From: Ainslie, William [/O=EXCHANGELABS/OU=EXCHANGE ADMINISTRATIVE GROUP (FYDIBOHF23SPDLT)/CN=RECIPIENTS/CN=F0961103D9BC495AB830CDC6DBA07B18-AINSLIE, WILLIAM]
Sent: 7/12/2021 5:39:21 PM
To: Mastrototaro, Jill [Jill.Mastrototaro@audubon.org]
Subject: RE: Attachments to Conservation Organization comments

Conservation Organizations Comments on the
Final Supplement No. 2 to the 1982 Yazoo Area Pump Project
Final Environmental Impact Statement

Figure 10, Yazoo Backwater Levee Remaining Freeboard 2019 Flood (0.3ft) (Source: USACE Mississippi Valley Division Presentation on 2019 Mississippi River Flood, Joey Windham, Chief Watershed Division)

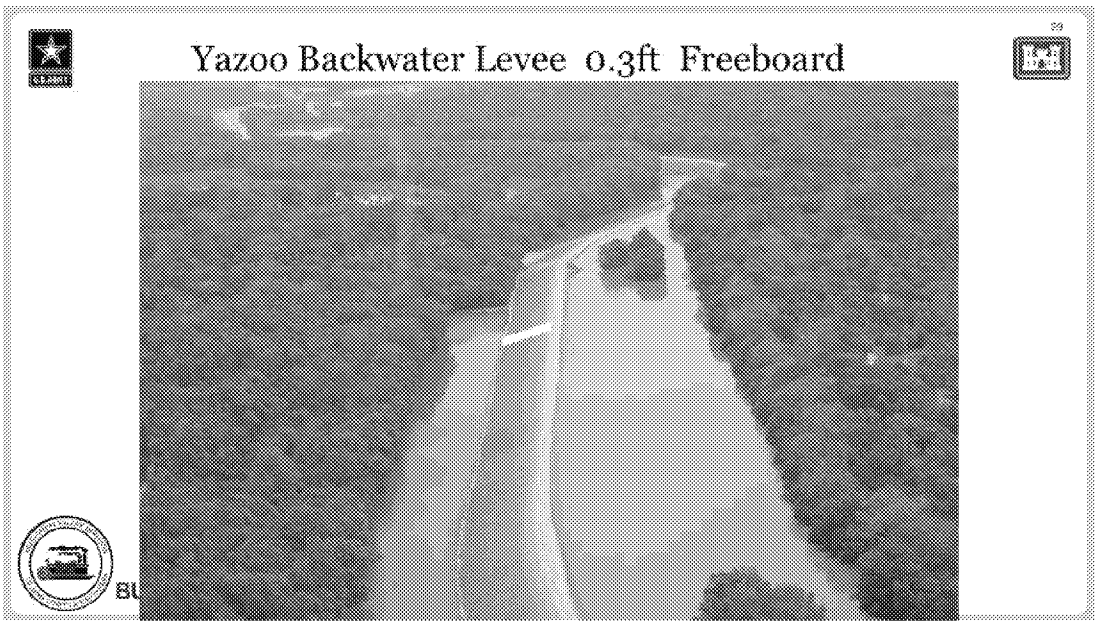
Based on this Corps analysis, had the Yazoo Pumps been operating in 2019, they would have overtopped the Yazoo Backwater Levee, which according to the Corps had just 0.3 feet of remaining freeboard during the 2019 flood, as demonstrated in this slide from a Mississippi Valley Division presentation on the 2019 Mississippi River flood. *See* Figure 10, below.

The portion of the Yazoo Backwater Levee that could be directly impacted by the Yazoo Pumps (that portion located south of Belzoni, MS) consists of "approximately 28 miles of earthen embankment." This portion of the Yazoo Backwater Levee (which is not accredited by the Federal Emergency Management Agency) has a moderate risk with **overtopping with breach the primary risk driver,** according to the National Levee Database.[138] Moderate risk is defined as follows: "Likelihood of inundation due to breach and/or system component malfunction in combination with loss of life, economic, or environmental consequences results in moderate risk."[139]

Figure 13, Completed Construction at Steele Bayou Location from USACE Presentation to EPA, Yazoo Backwater Project Brief Region IV 15 May 2019

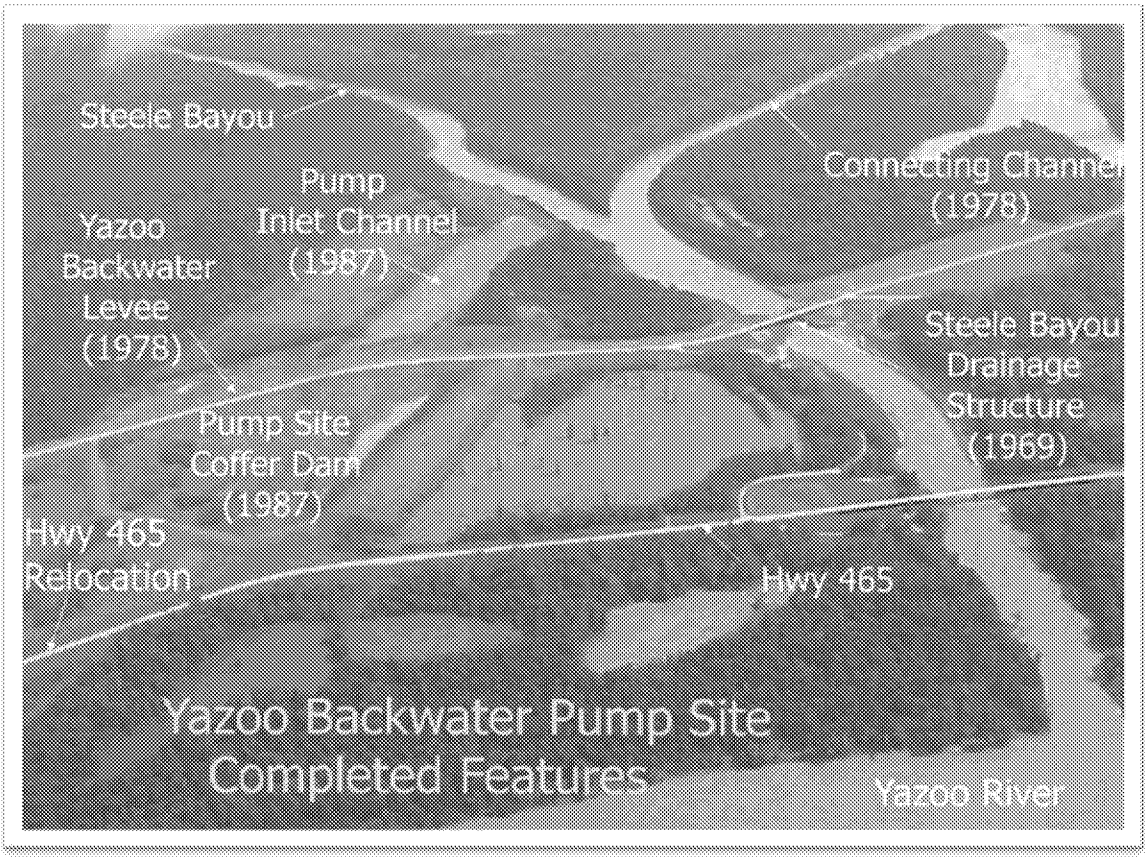
In short, if the Yazoo Pumps are moved to the Deer Creek location, the project could not proceed unless a non-federal sponsor could provide the non-federal cost share of 35% of total project costs (including mitigation). So, for example, if it costs $440 million to build the Yazoo Pumps at the Deer Creek location, the non-federal sponsor would be required to contribute $154 million of those costs, plus all necessary lands, easements, and rights of way. If construction costs increase, the costs to the non-federal sponsor would also increase since the non-federal cost share is based on a percentage of total project costs (including mitigation).
